BIENNIAL REPORT 111th CONGRESS

AMERICANS WITH DISABILITIES ACT INSPECTIONS RELATING TO PUBLIC SERVICES AND ACCOMODATIONS

**Office of Compliance
August 2012**

Accessibility in the Legislative Branch – Report on Americans with Disabilities Act Inspections Relating to Public Services and Accommodations during the 111th Congress

ADA Survey Results for Curb Ramps on Sidewalks Surrounding Longworth H.O.B.

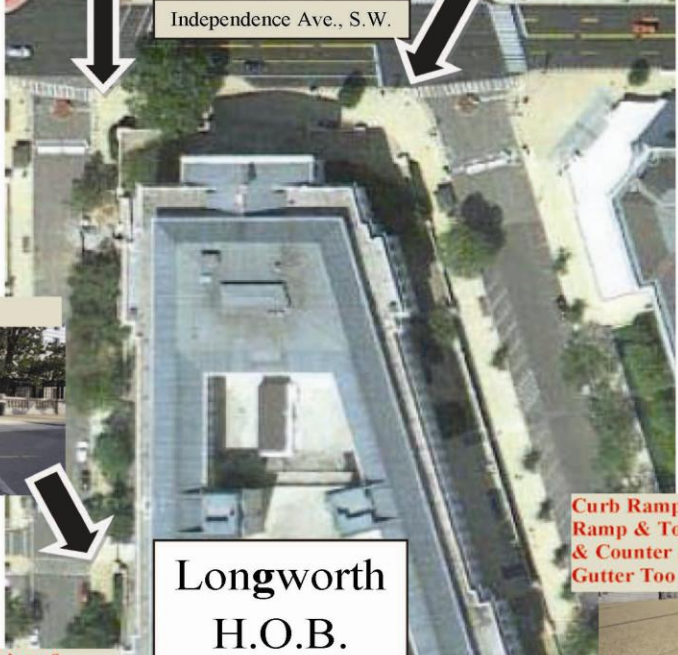
Curb Ramp 19 – Counter Slope of Adjoining Gutter Too Steep (A) & Other Barriers (C)

Curb Ramp 12 – Running Slope Too Steep (A) & Water Accumulates at Gutter (C)

Curb Ramp 21 – Cross Slope of Ramp & Top & Bottom Landings All Too Steep (All Severity Code A), Slab Joints & Cracks Too Wide (A) & Detectable Warning Deteriorated (C)

Protruding Tree Branch Creating Barrier

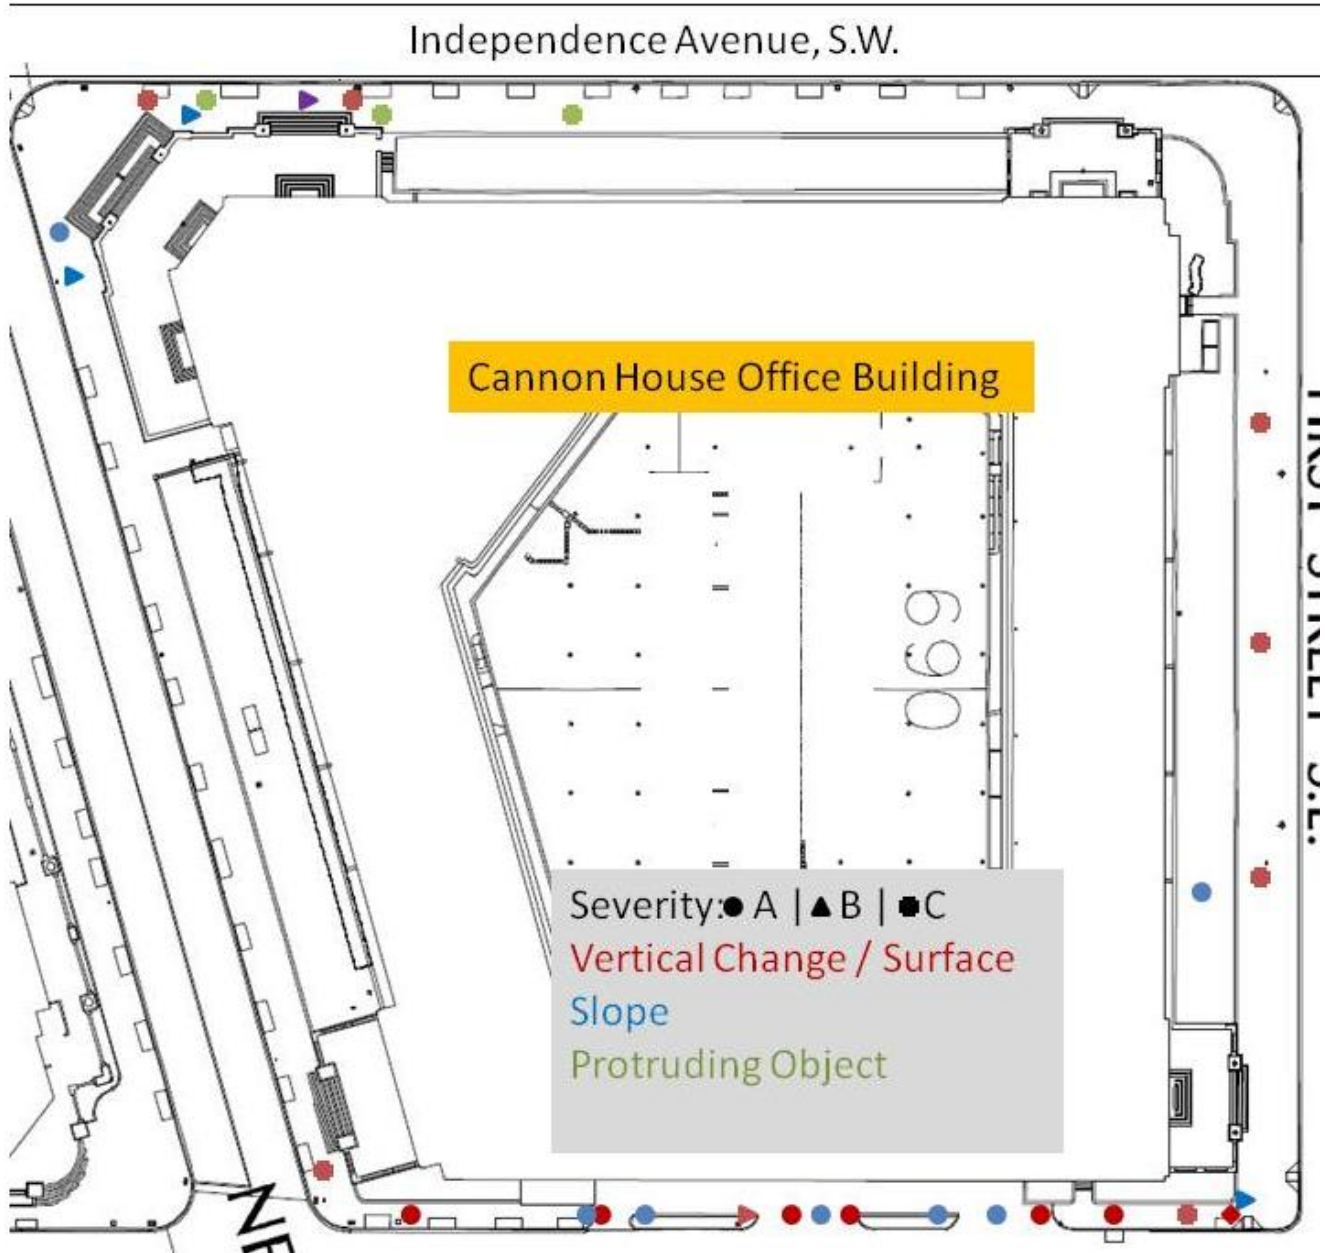
The OOC found 11 barriers relating to objects that protrude into the sidewalk corridors. Most of these are related to tree branches or plants that have grown into the corridor. Two of the 11 barriers are rated as “A” severities because, in one case (Barrier 88), the tree branch is thick enough to pose a cutting hazard, and in the other case (Barrier 129), the protruding ledge has a rough surface that could cause abrasions during contact. Of the remaining 9 barriers, 8 are rated as “C” severities while 1 is rated a “B” severity.
